RCSL: 44 - RT 1911

SERIAL EFFECTIVITY RCM705, S/N 438-444, 455-486, 500 and upwards	EQUIPMENT AFFECTED RC700 RC702, RCM705, REC702 Rectifier and Interconnection
--	---

FIELD CHANGE ORDER

NO. 19-015

MODIFICATIONS ON THE REC702:

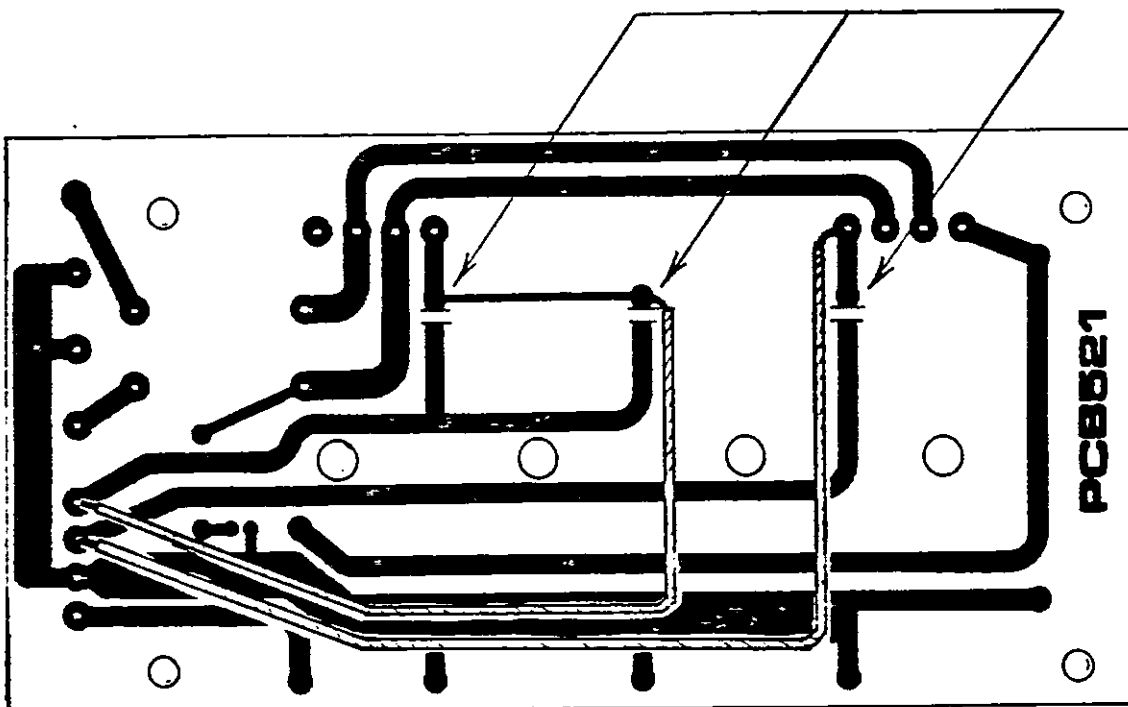
1. Cut trace at these
3 locations

2. Mount the two wires as shown.
It is important that the physical routing of the wires
are as close as possible to the one shown.

MODIFIED CABLING:

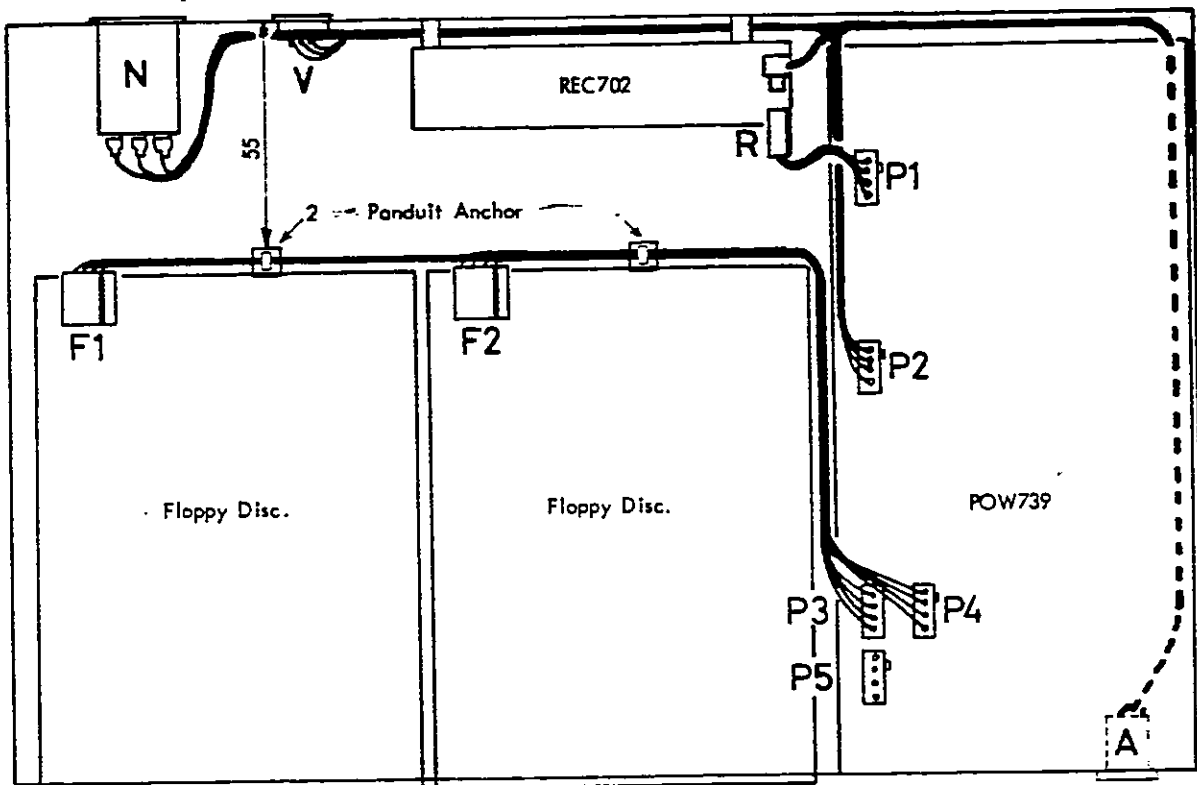
- The power cables for the floppy drives are routed close to the drives.
- All other power wires are routed close to the back of the chassis.
